April 23, 2007

**RE: Revisions to Work Plan for Soil and Groundwater Investigation
Allied Engineering Co., 2421 Blanding Avenue, Alameda, CA
Fuel Leak Case No. RO0002601**

Site Plan - Proposed Boring Locations

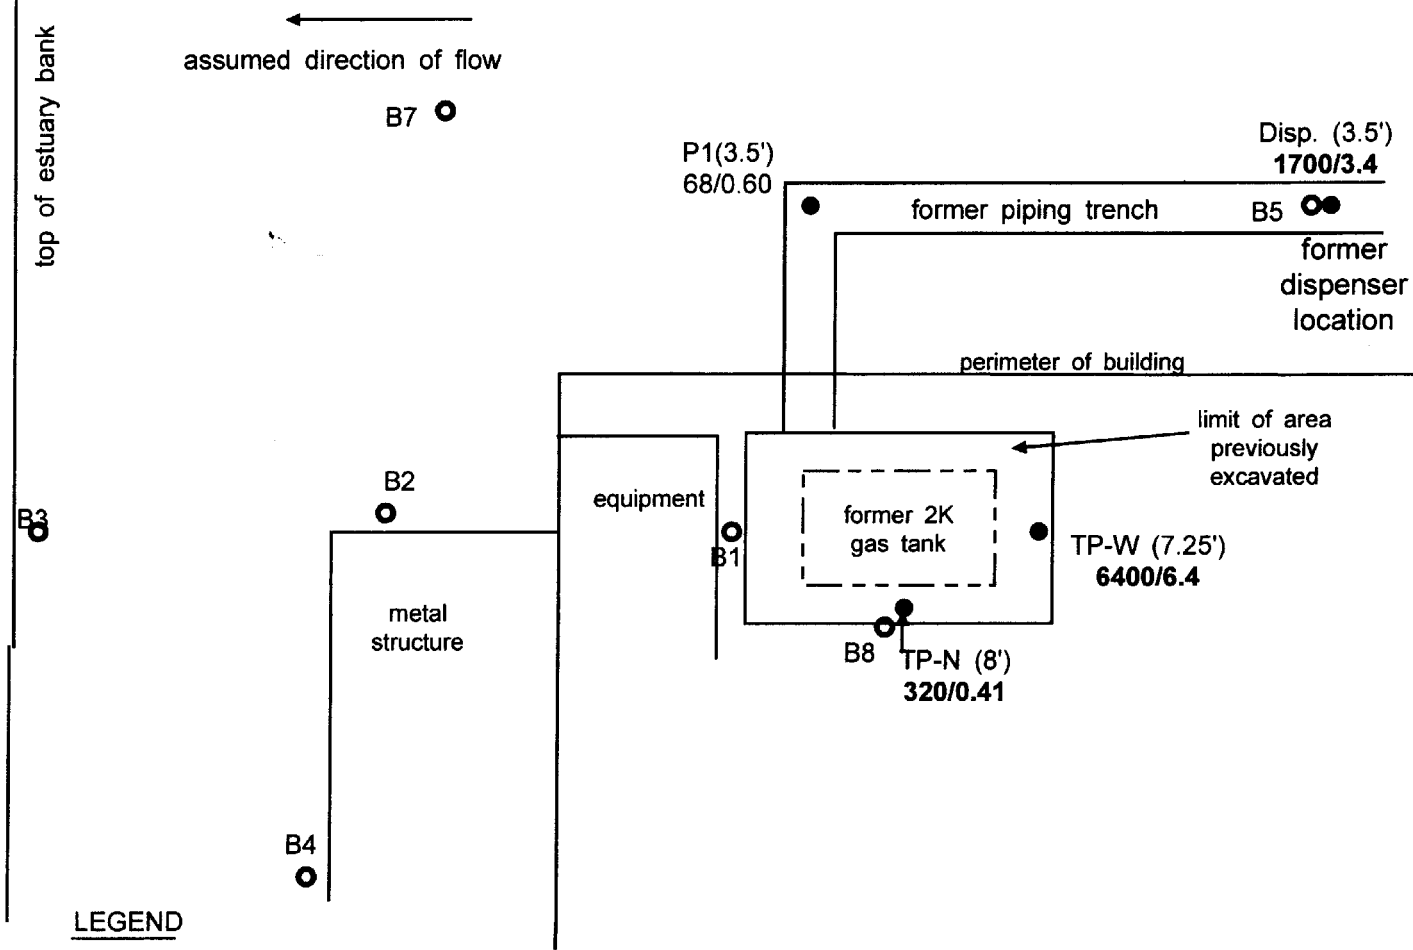
Technical Comment No. 1 – An additional boring (B8) will be located adjacent to the south sidewall of the former tank pit, as shown on the revised Figure 1 (attached). Soils will be screened with a PID during drilling. If no staining, odor, or elevated PID readings are observed, soil samples will be collected from each boring at five feet bgs, at the capillary fringe immediately above the zone where groundwater is first encountered, and 12 to 15 bgs. Grab groundwater samples will also be collected.
